State College Area School District  
Ferguson Township Elementary School  
**Preliminary Daylight Analysis**  
**October 1, 2009**

The purpose of this analysis is to determine the daylight performance of the design as of September 2009 and to provide performance recommendations.

## 2nd Floor North Facing Classrooms

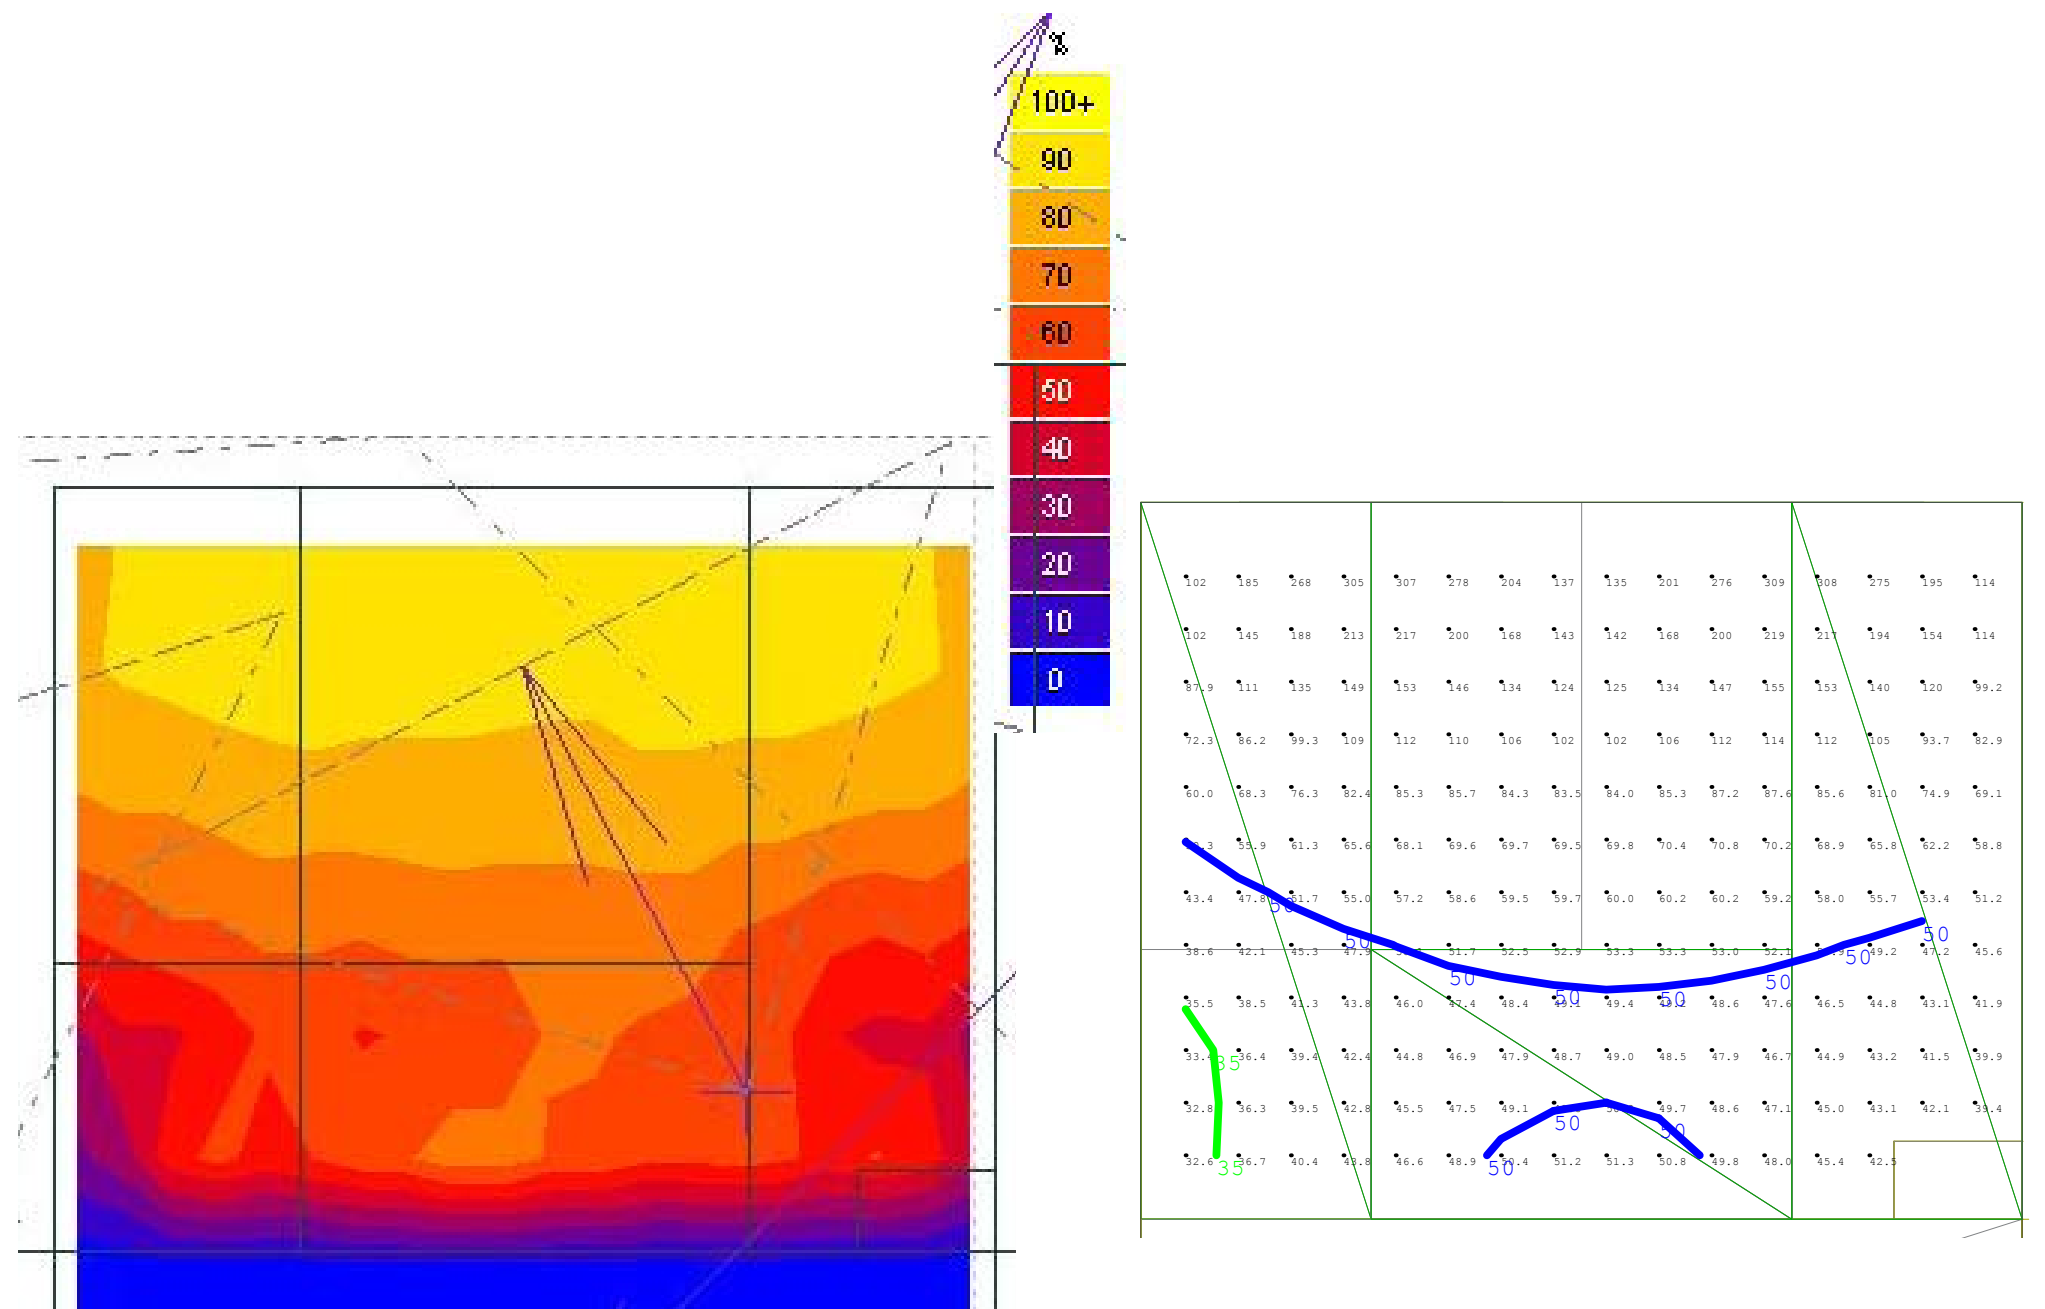
The largest portion of the space is meeting the target DAR. This is due to the bilateral daylighting condition. However, the distribution of light is not as even as it should be due to the clerestory covering only half of the space. Some light loss may also be occurring through the transom window into the hallway.

The clerestory should span the entire width of the space to create a more even distribution of light. There may be some contrast issues because of this.

It is suggested that the transom window to provide light to the hallway be removed. This will bounce more light into a regularly occupied space.

Electrical lighting should be installed to compliment the daylighting. Based upon the analysis and a bilateral daylighting condition it would be feasible to have the first two rows dimmable with a daylight sensor and the third row be stepped switched.

## 2nd Floor North Hallway

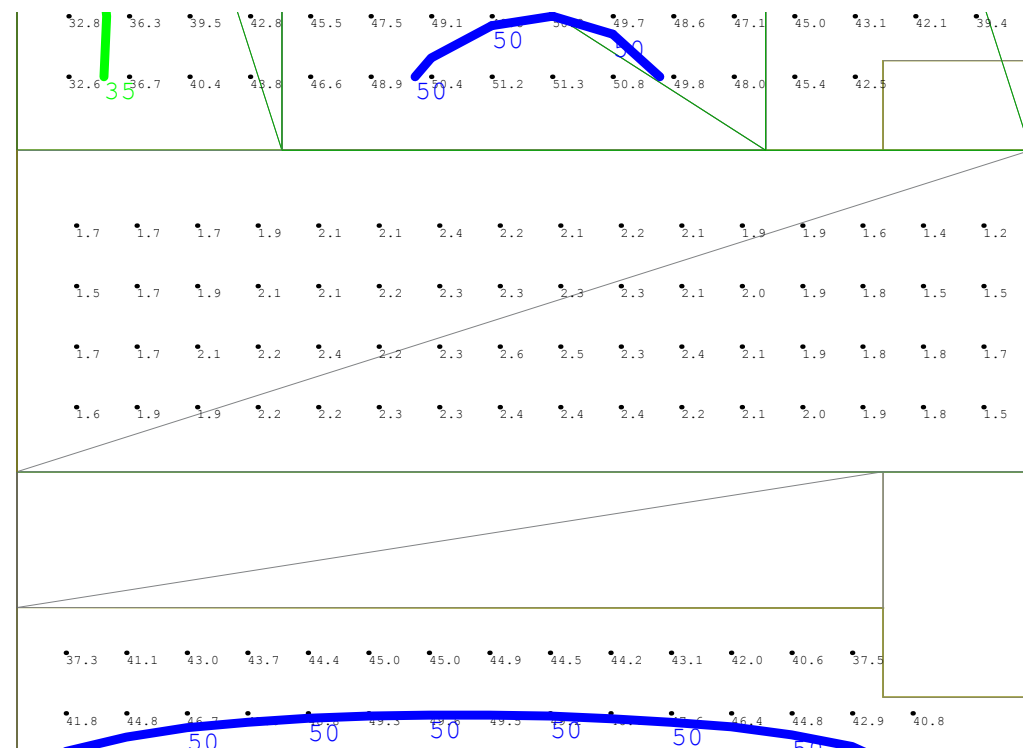
Due to the height of the space and the amount of glass that the light must pass through before it reaches many of the viewable surfaces of the space, it is recommended that the transom window be removed.

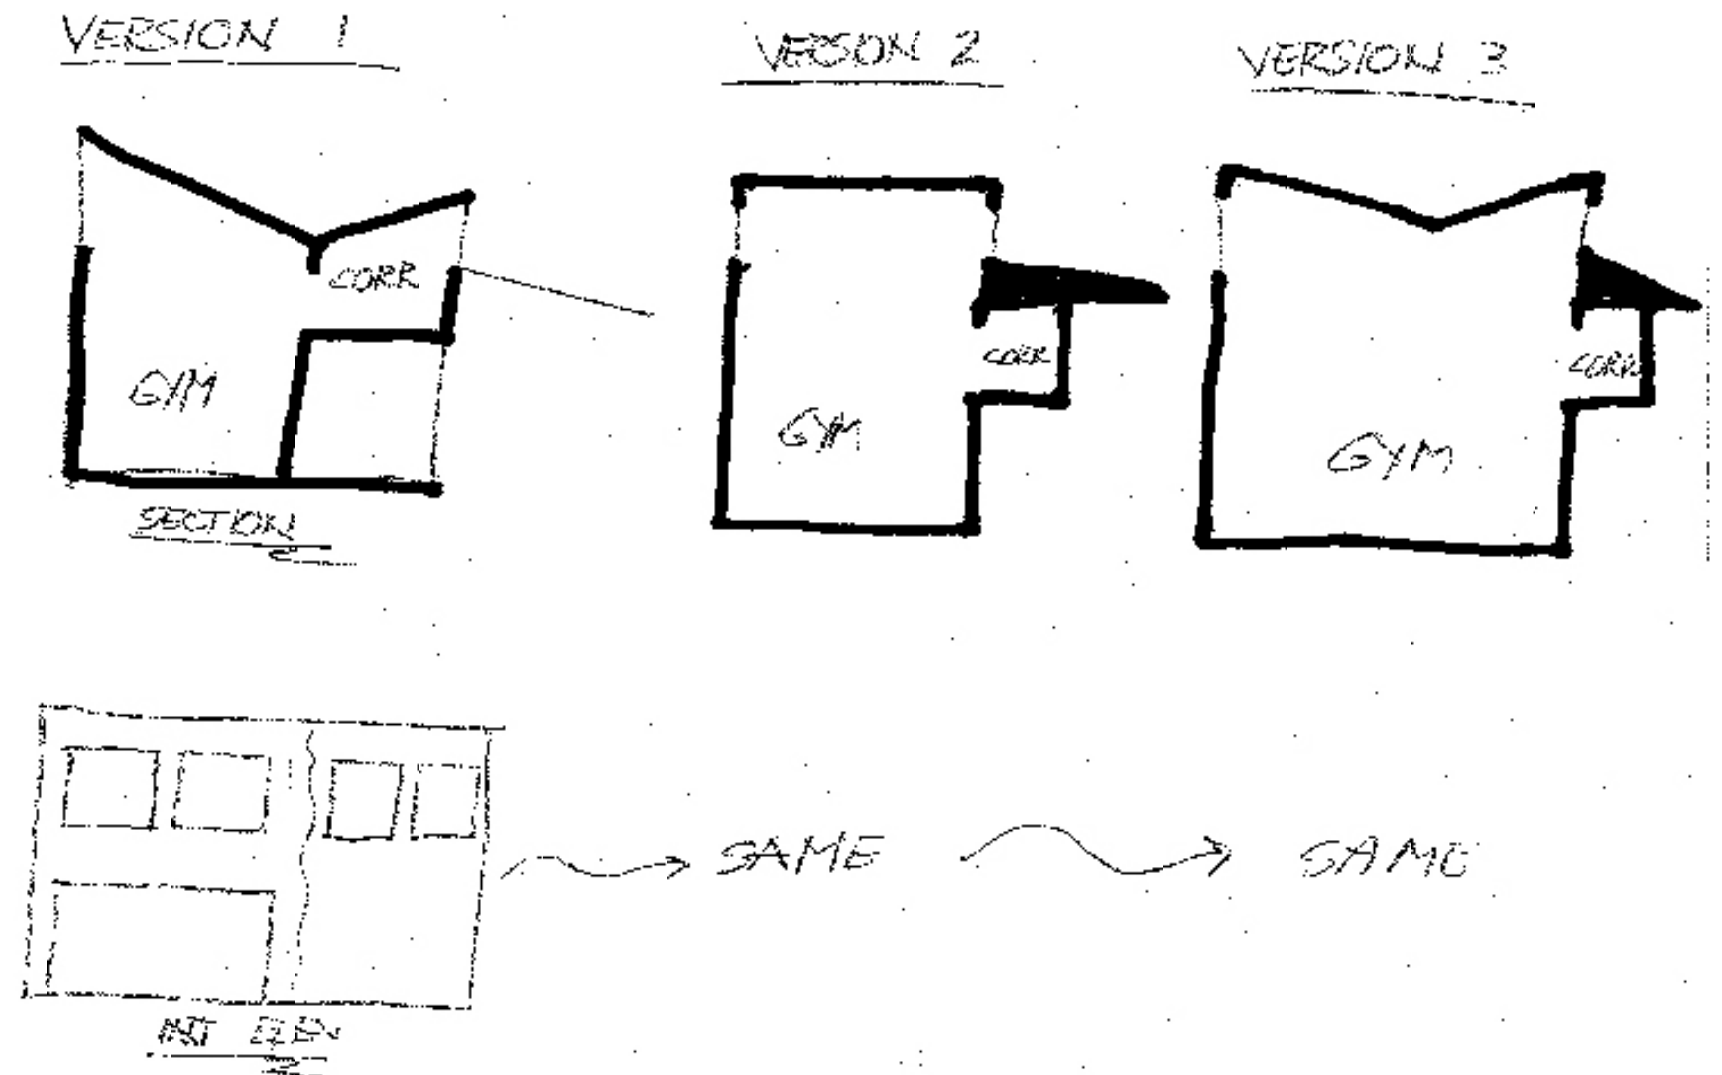
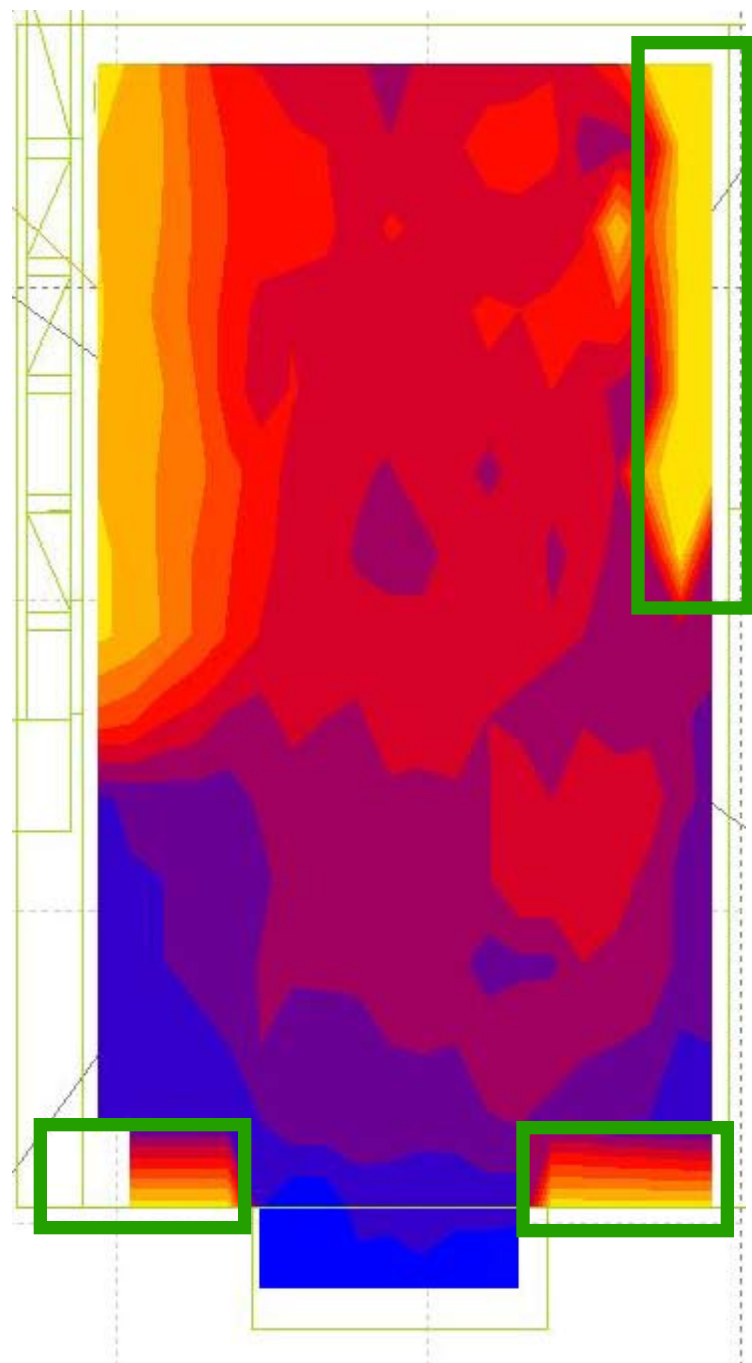
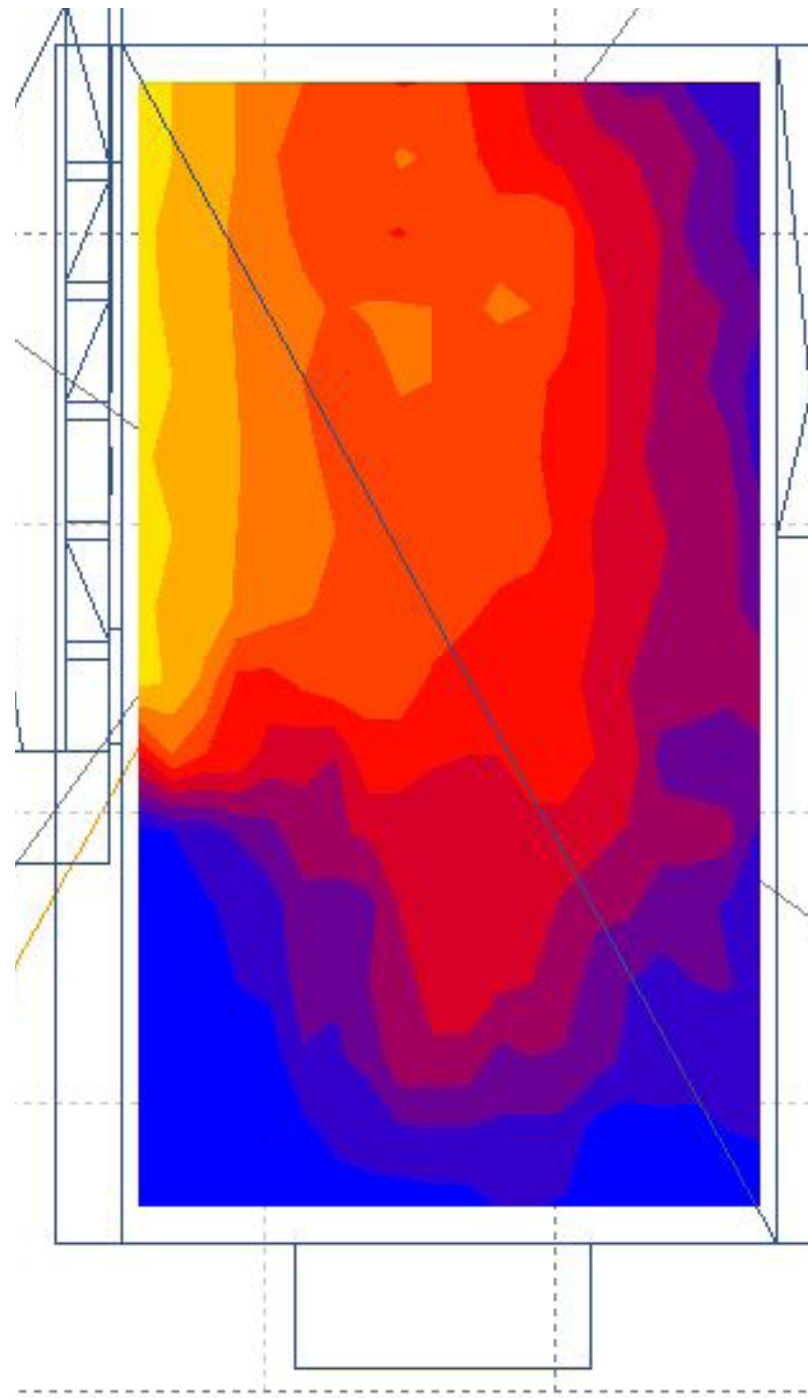
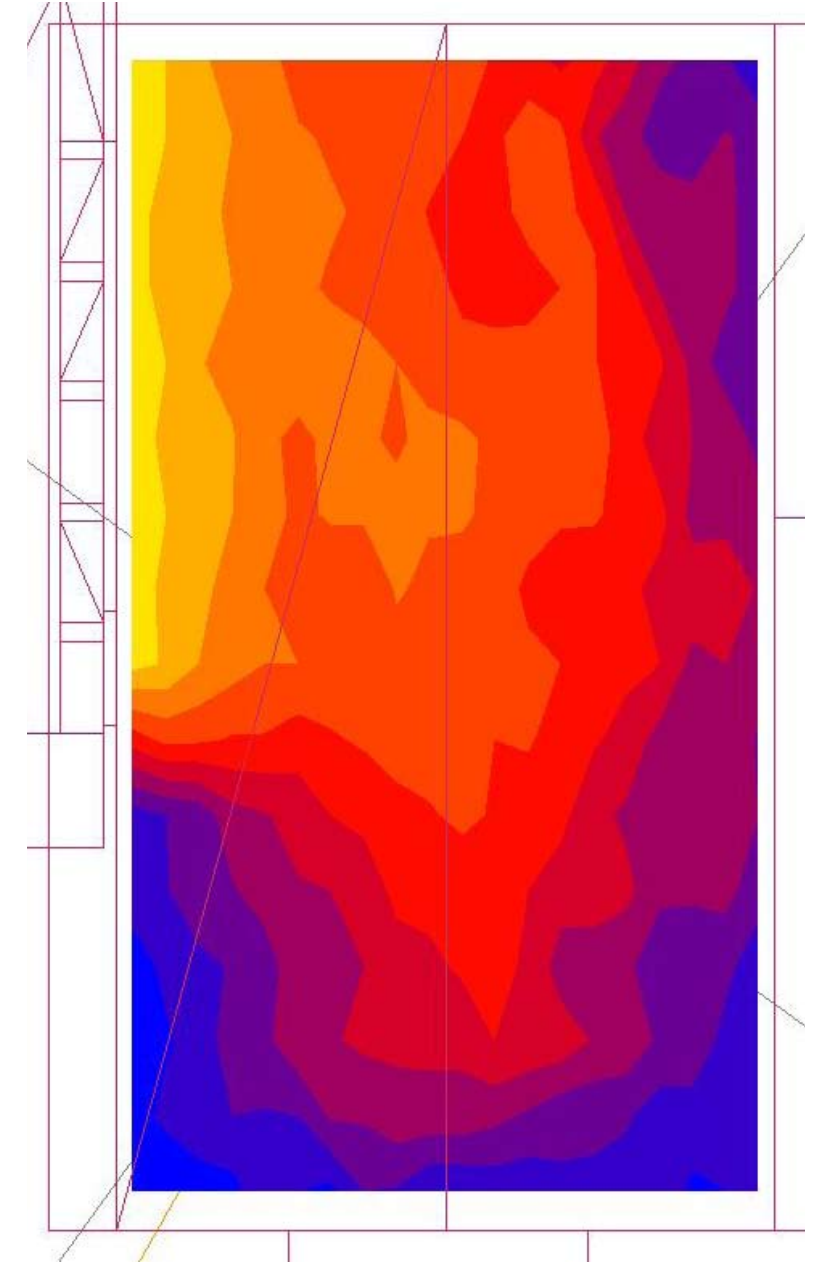
Three scenarios were run to look at three possibilities in effectively daylighting the gymnasium. Scenario 1 is the base design, Scenario 2 has a flat roof with the east clerestory located in the gym, Scenario 3 is the same as 2 except the roof is a butterfly roof.

The target DAR for the gymnasium is 80% with a minimum illuminance value of 35fc. The scenario that comes the closest to that goal and provides an even distribution of daylight in the space is Scenario 3.

To meet the daylighting goals and to provide the best quality of daylight into the space, it is recommended that scenario 3 is used.

It has been noted that glazing at the floor along the west facade will remain. A glazing with a VLT of no more than 50% should be used. It is recommended that the amount of glazing be reduced and the entry roof be extended and or angled to help reduce the times of direct solar penetration.

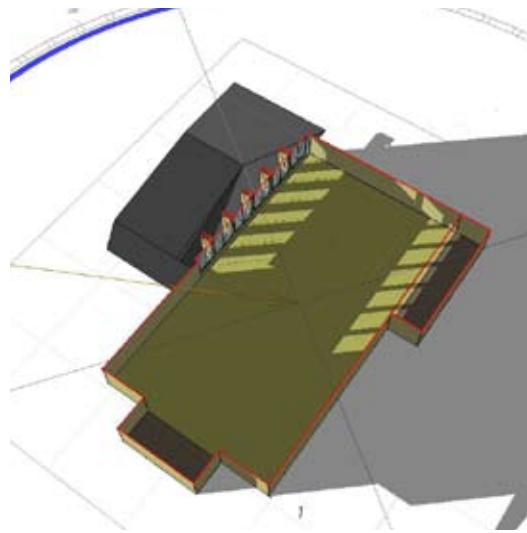
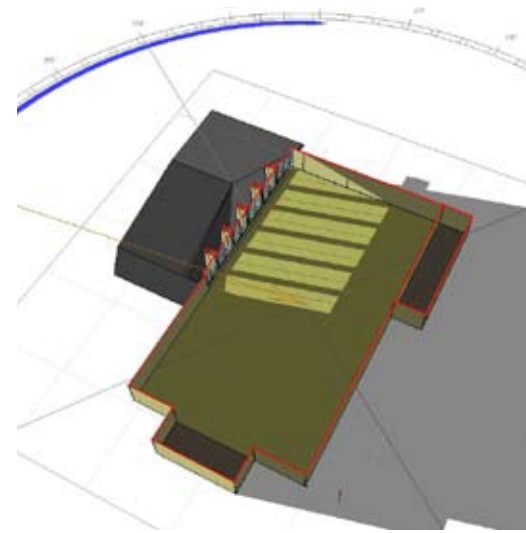
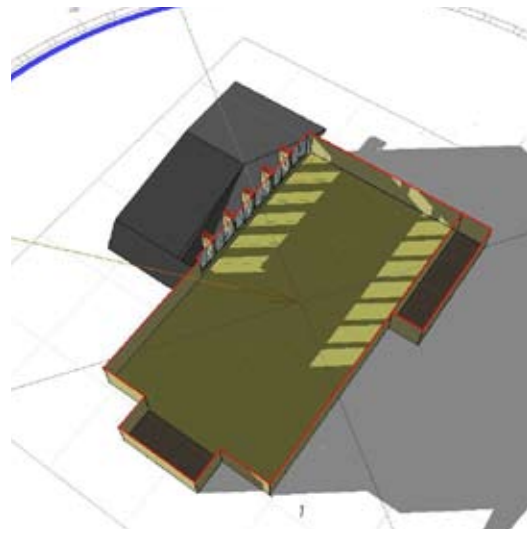
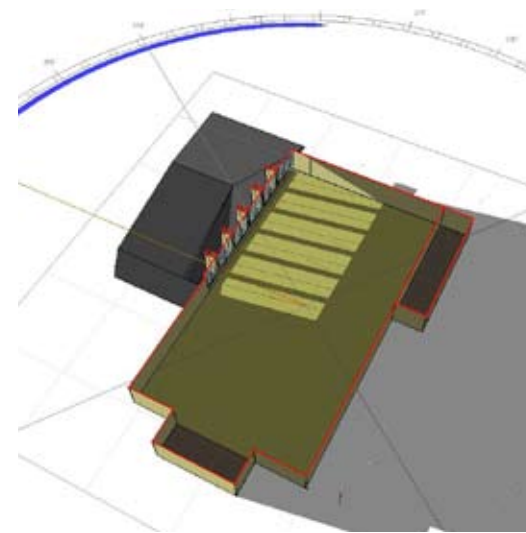
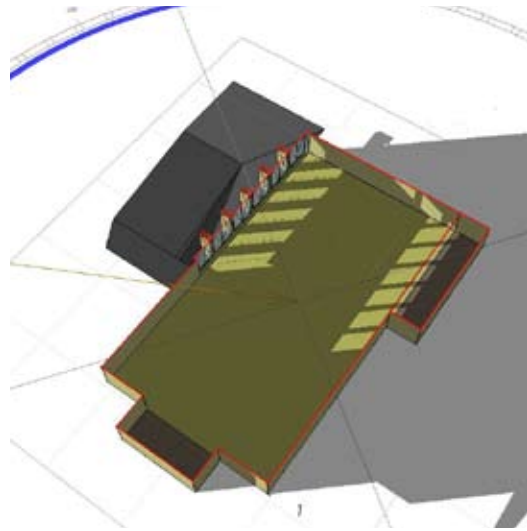
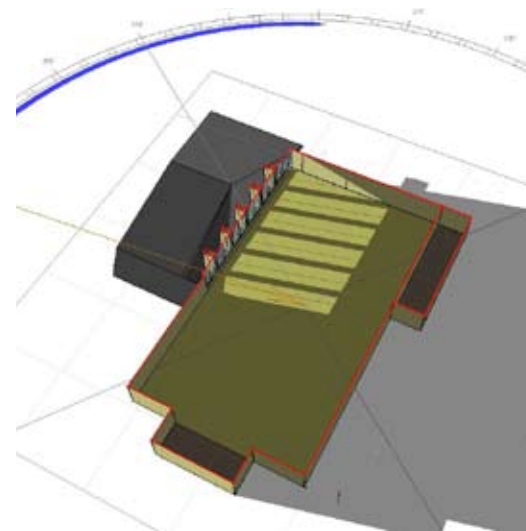
From the beginning of October till the end of March, there will be issues of direct solar penetration. In those months, this will occur during the school day. As the year moves on, from March until September, the effects will be greater later in the evening.

The main focus is to reduce this issue during the school day. If the overhang is extended 2'-0" and dropped 2'-0" in height, this will almost completely eliminate the occurrence of direct sunlight onto the playing surface. Another option is to angle the overhang, the exact angle and length has not been determined until this option is discussed with the design team.

The only really effective means to eliminate the direct sun from the entering the space in the late afternoon and early evening hours is to eliminate the glazing. This scenario will also produce glare in the space causing discomfort to the occupants. If this glazing is not removed, then is recommended that a glazing with no more than a 50% VLT be used. The use of a solar shade would reduce the effect of glare and direct solar issues in the space.
